Product change notification

P9 range change from shiny to matt chrome

PCN Document No.	1SFC151070K0201	Date of PCN:	2022-8-10
PCN issued by:	Tuba-JianLin Kuang	PCN valid as of:	2022-8-10
Product Manager:	Pavlo Tkachenko	Obsolescence Date:	
R&D Manager:	Doree-MingShi Fan Jay-JieJun Lv	Change Date:	P9ML*, P9MM*: 2022 Q4 P9MC*: 2023 Q1 Nut: 2023 Q1
Products impacted:	P9ML*, P9MM*, P9MC* and nut included in all P9M operators		
Impact on Form/Fit/Function:	[X] Form [] Fit [] Fctn		Impact on reliability: [] Y [X] N

Figure 1 Pilot light P9ML
P9MN

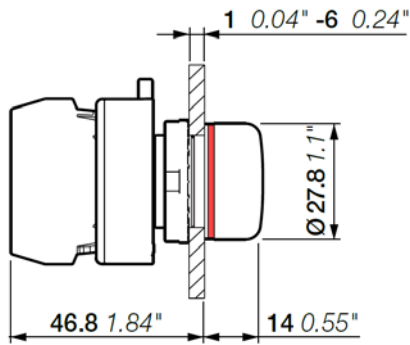
The appearance will be changed from shiny chrome (Picture A) to matte chrome (Picture B) on Pilot lights P9ML*, Joysticks P9MM*, Toggle switches P9MC* and the fastening nut in all P9 range operators.

Marked in red is the areas that will be visibly changed from front of the panel.
